DAP-2024-13

UP25/64 – Lot 274 (No. 17) and Lot 275 (No. 19) Almondbury Road and Lot 585 (No. 3)

Bragor Place, Ardross - 57 Multiple Dwellings and 3 Grouped Dwellings

Claimed 'community benefit' - Flawed

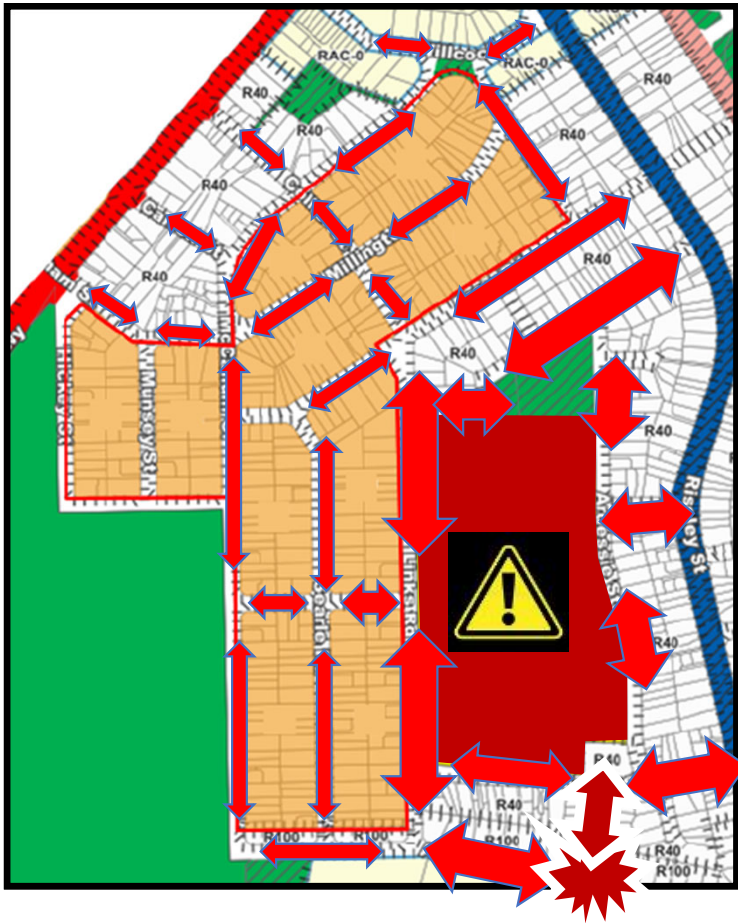
- A number of community benefits claimed **\$3.94m** – not valid
 - MCCSP framework doesn't apply – applicant error
 - 'Exemplary design'
 - 'Business centre'
- Actual value ? **\$498k** ? (verge/streetscape enhancements, shared accessway and financial contribution)

CoM: '*Whilst the community benefits proposed are **significant**, they are **not considered to suitably mitigate the considerable discretion to the height controls stipulated by the MCCSP.***'

?Are they **really** significant?
